Planning Committee

S25/1083

Proposal:	Listed building consent for the conversion of the infirmary and casualty ward together with associated demolition and external alterations to form 11no. dwellings (Use Class C3)
Location:	Stamford And Rutland Hospital, Ryhall Road, Stamford, PE9 1UA
Applicant:	Grey Friars Development
Agent:	Planning Insight
Application Type:	Listed Building Consent
Reason for Referral to Committee:	Accompanies application for major development which requires a Section 106 Agreement .
Key Issues:	Impact on heritage assets
Technical Documents:	Design and Access Statement Heritage Impact Assessment Heritage Appraisal Archaeological Desk Based Assessment Archaeological Evaluation Report

PROPOSED FLOOR PLANS (BASEMENT AND GROUND FLOOR) – INFIRMARY BUILDING

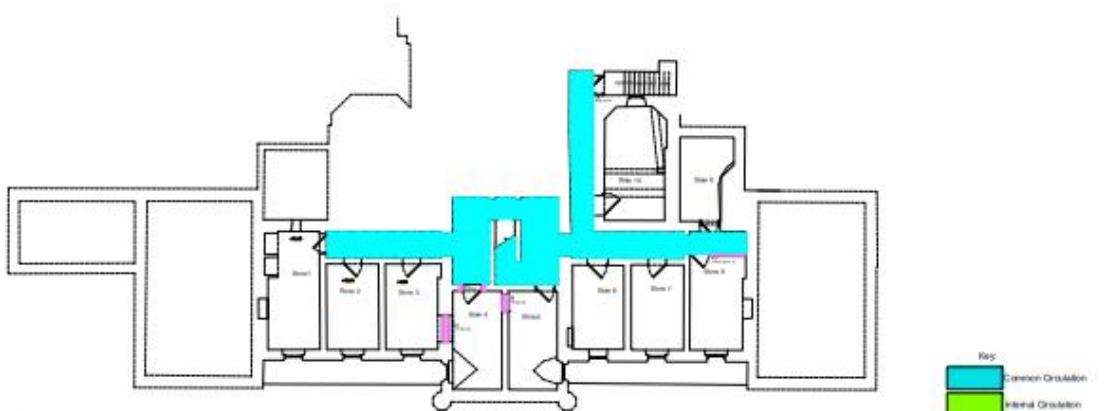
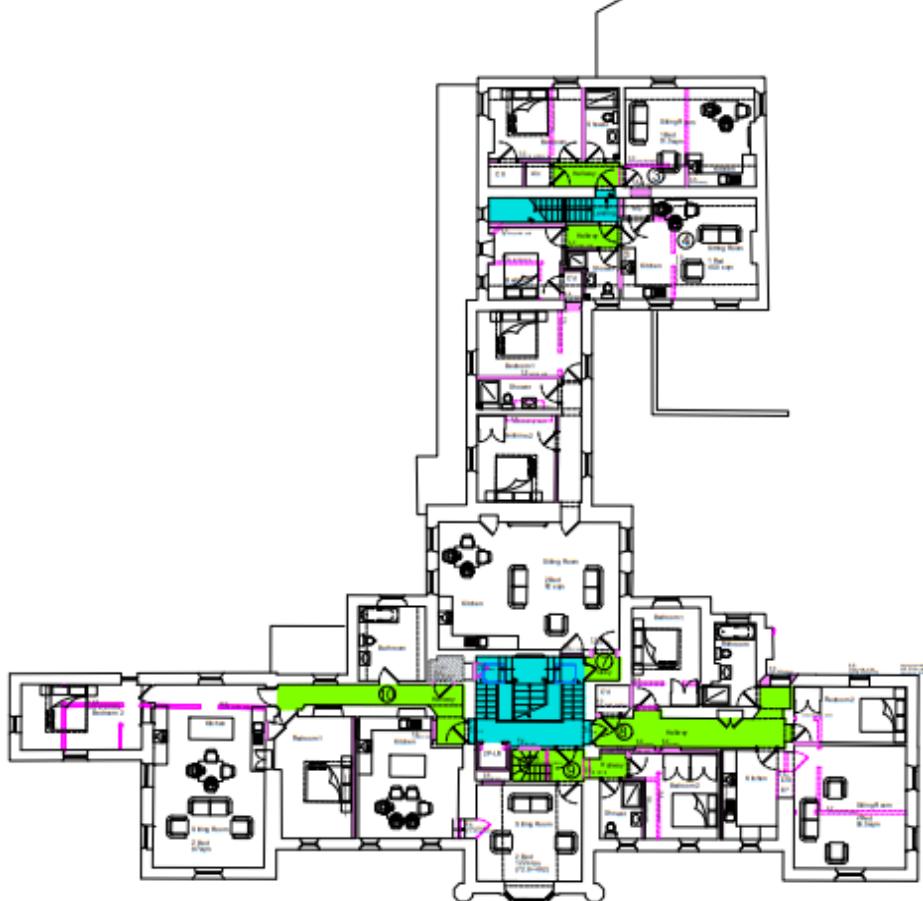
5.5.7 Basement: The basement is well maintained, with a fairly expansive amount of rooms with vaulted ceilings, and small windows providing light. The works proposed to the basement are very minor, comprising only of the blocking off some existing doorways to provide a store area for all proposed flats. The use of tanking or other means of invasive damp proofing should be avoided to maintain the breathability of the exposed masonry. The use of lime-render may be considered appropriate if required. There are no concerns regarding the works proposed.

5.5.8 Ground Floor: The ground floor is proposed to be separated into four separate units (Units 1, 2, 5 and 6), all of which are two-bed units. A series of walls are proposed to be removed. Most of these are of modern origin. A number of doorways are also being proposed to be blocked off or altered. These works, while partially affecting historic fabric, would overall be considered a minor loss of historic fabric. These alterations are therefore considered to be acceptable. An elevator is proposed to be installed within the entrance hall. This would slightly interrupt the symmetry of the staircase, which is framed by four centred aches, matching the front doorway design. It is however noted that the staircase itself would remain

- 5.5.9 The modern lowered ceilings are proposed to be removed. A record should be provided if any historic features are being discovered during the course of these works. It is noted as mitigating factors that the currently boarded off windows are to be re-opened and restored. Unsuitable uPVC windows are to be replaced with timber windows. Historically valuable fireplaces are to be retained or reused within the structure. Built-in cupboards of historic origin are also proposed to be retained. Any doors of historic value should also be retained or reused where possible.

PROPOSED FIRST FLOOR PLAN – INFIRMARY BUILDING

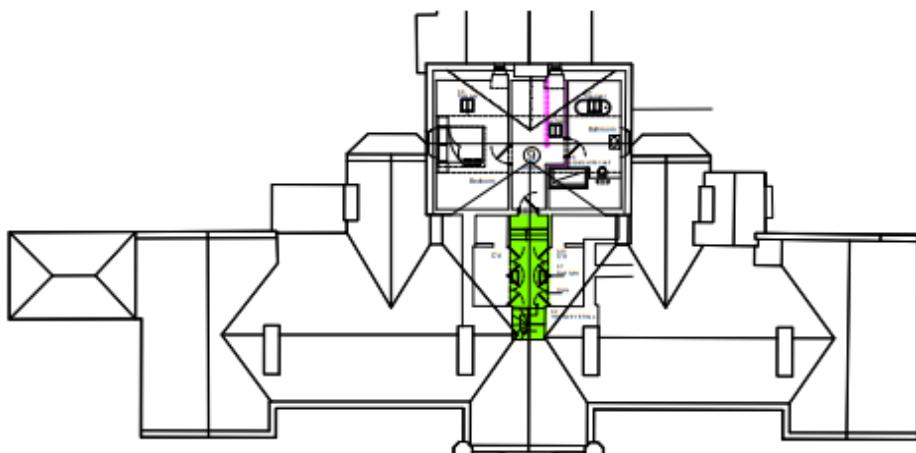
- 5.5.10 First and Second Floor: The works proposed to the first floor are of similar character as on the ground floor. In total, six units are to be created, four of which are 2-bed units, two are to be 1-bed units. One unit is set across the first and second floor. A number of internal walls are proposed to be removed and new partitions are proposed. A number of doorways are also being proposed to be blocked off or altered. These works, while partially affecting historic fabric, would overall be considered a minor loss of historic fabric. The modern lowered ceilings are proposed to be removed. This will have no impact on historic fabric.

- 5.5.11 A record should be provided if any historic features are discovered during the course of these works. Decorative features such as coving, picture or dado rails should be retained. Any doorways to be move or altered should retain their historic architraves where existing. Consideration and justification for the moving of a doorway and architraves should be provided; where architraves are kept in situ, details should be provided on how this is incorporated as a feature into the design of the room. It is noted that some rooms retain historic timber flooring, this should be retained. Restoration of the timber flooring would be a positive improvement. These alterations are therefore considered to be acceptable, based on the implementation of the conditions noted.

PROPOSED ELEVATION PLAN – INFIRMARY BUILDING

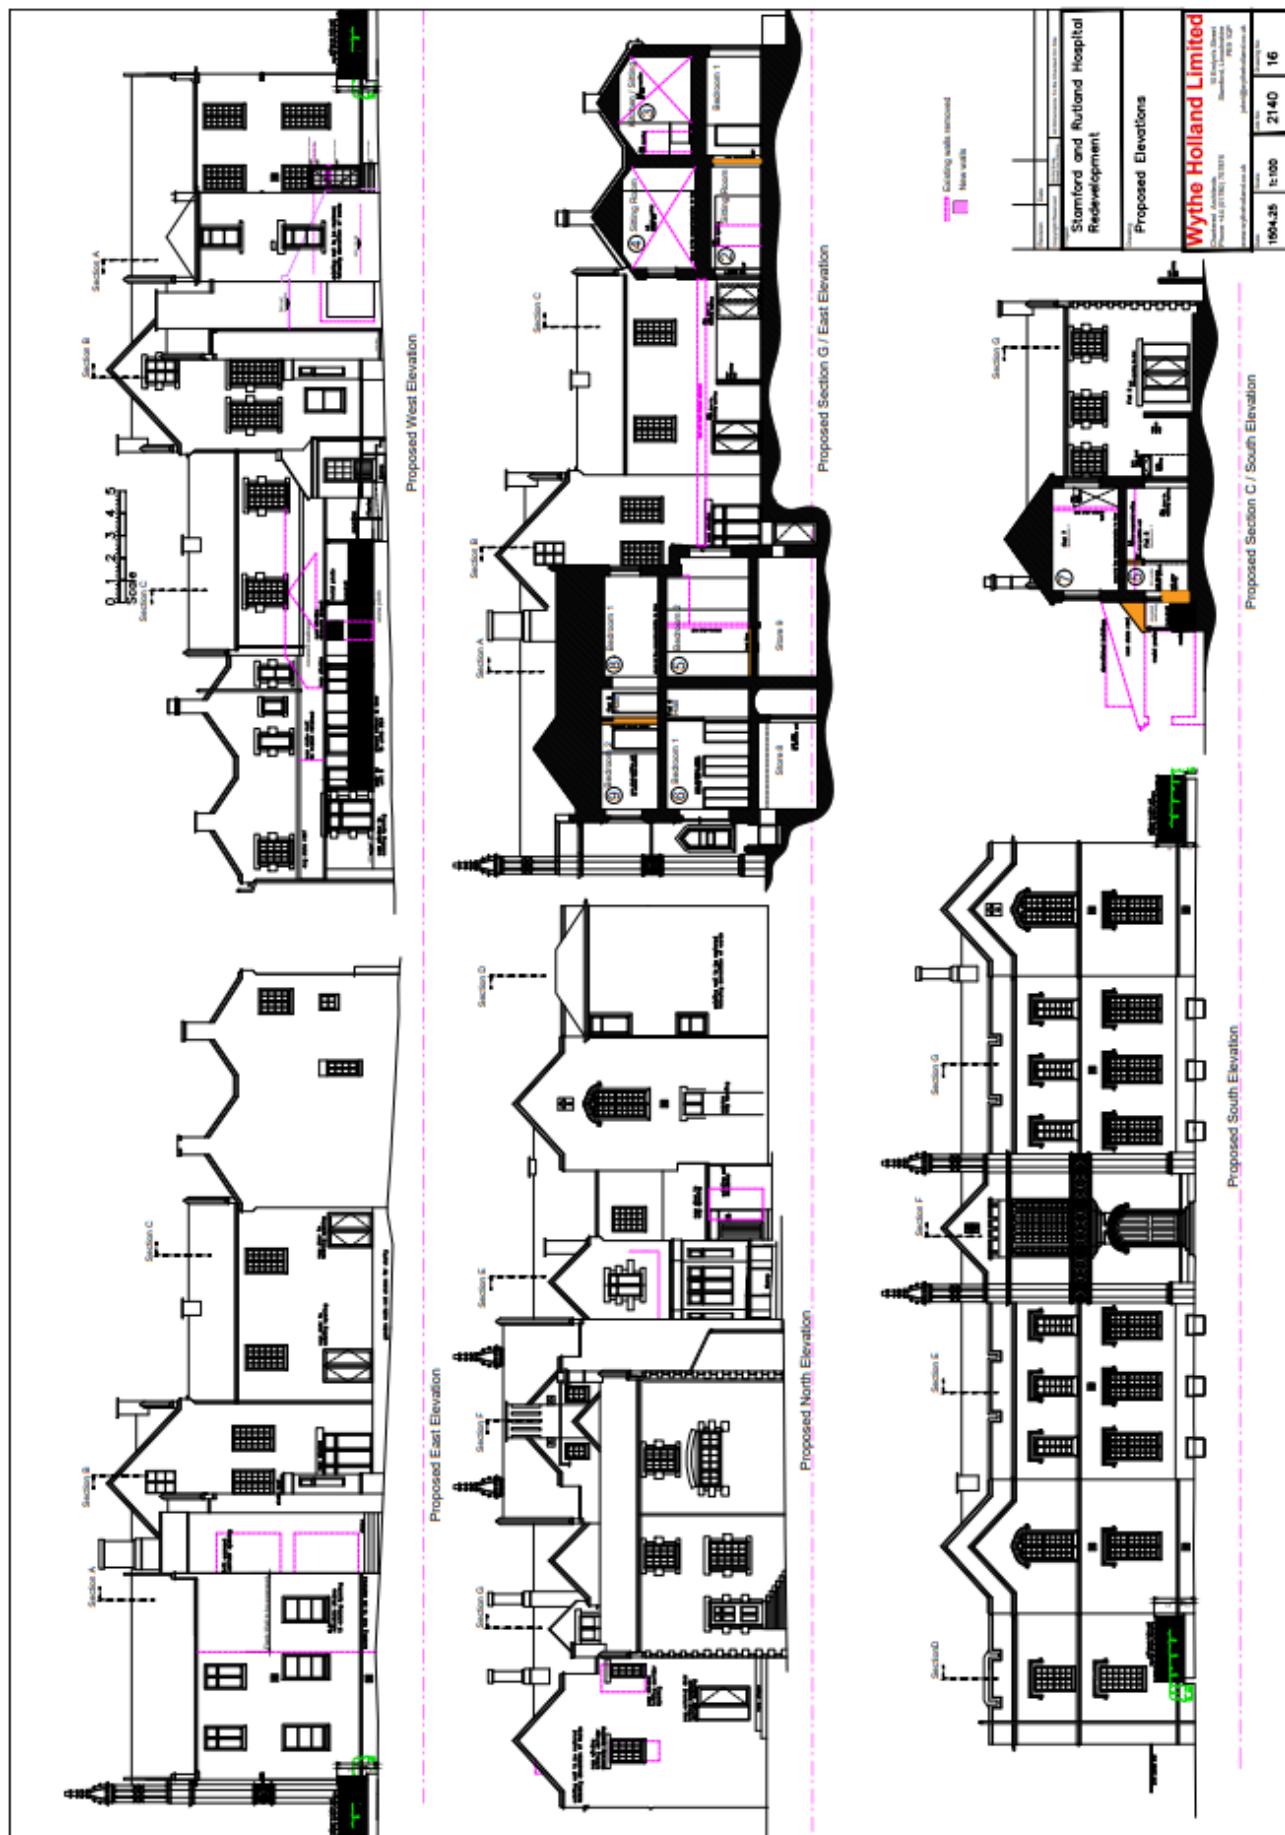
5.5.5 Exterior: The works proposed to the exterior of the building are predominantly comprising restoration works, and minor alterations such as blocking windows/doors or changing their size, a focus for which is to the sides and rear of the building. It is also proposed to install a 1.8m high railing upon the dwarf wall fronting the building. These works proposed are considered to be beneficial to the building. Care should be taken that any stone works repairs or alterations are matching the existing masonry. Lime mortar should be utilised for any pointing. Detailed drawings for any joinery proposed should be provided, e.g. windows and doors. These should be of timber, although metal windows could be considered acceptable where they match the existing metal windows. It is noted that existing windows of historic significance, such as the timber and metal windows, are proposed to be restored, and secondary glazing is proposed to be installed. The secondary glazing should be appropriately scaled to the existing fenestration, to not interfere with the external appearance of the building. Any areas abutted by the structures to be demolished should be made good with appropriate matching masonry and mortar, and a record produced for any features uncovered during the demolition works.

PROPOSED ELEVATIONS AND FLOOR PLANS – CASUALTY BUILDING

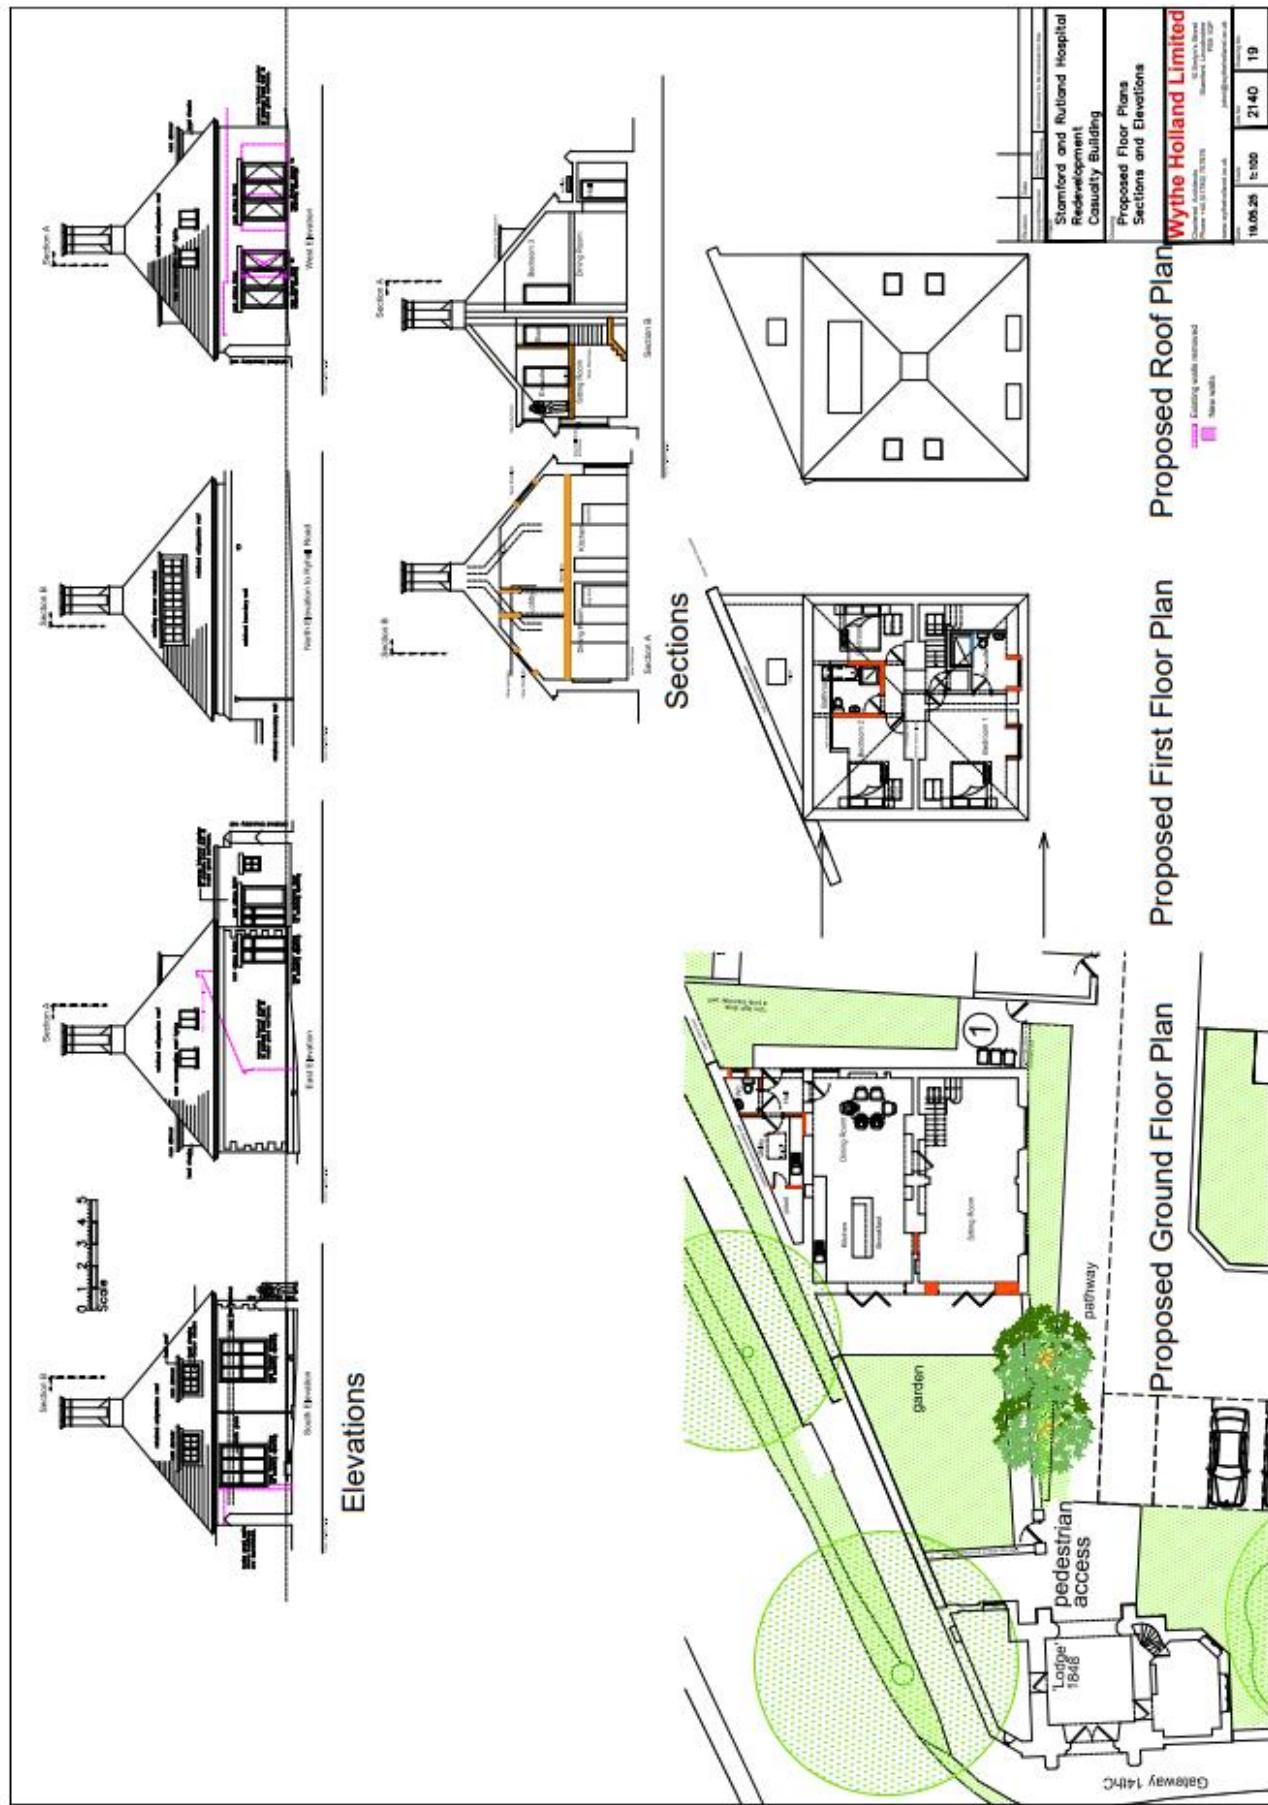
- 5.5.12 **Casualty Building:** The Casualty Building is a small structure currently interconnected with the infirmary by the 1929 structure. Once these are demolished, the building is to remain detached, as a single dwelling. Any areas abutted by the structures to be demolished should be made good, and a record produced for any features uncovered during the demolition works. The building is considered curtilage listed. The building retains a Collyweston tile roof, which is proposed to be retained. New dormers and conservation roof lights are proposed to be installed, and the existing large dormer on the north elevation is to be retained. The new dormers and rooflights are to be set lower along the east, west and south roof pitches, which would reduce the visual interruption to the roofscape.

- 5.5.13 All later extensions to the building, with the exception of the small hallway and utility area to the north of the building, are proposed to be demolished, restoring the historic appearance of the building.

- 5.5.14 A new floor is proposed to be installed, creating a first floor, which is to create three bedrooms, an ensuite and a bathroom. This would intrinsically change the internal layout of the building. It is, however, appreciated that the building would otherwise be of limited available space. A full Building Recording (to a 2/3 Level at minimum) of the building should be undertaken prior to the proposed alterations. Joinery details of all new windows, dormers, skylights, doors and the staircase should be provided.
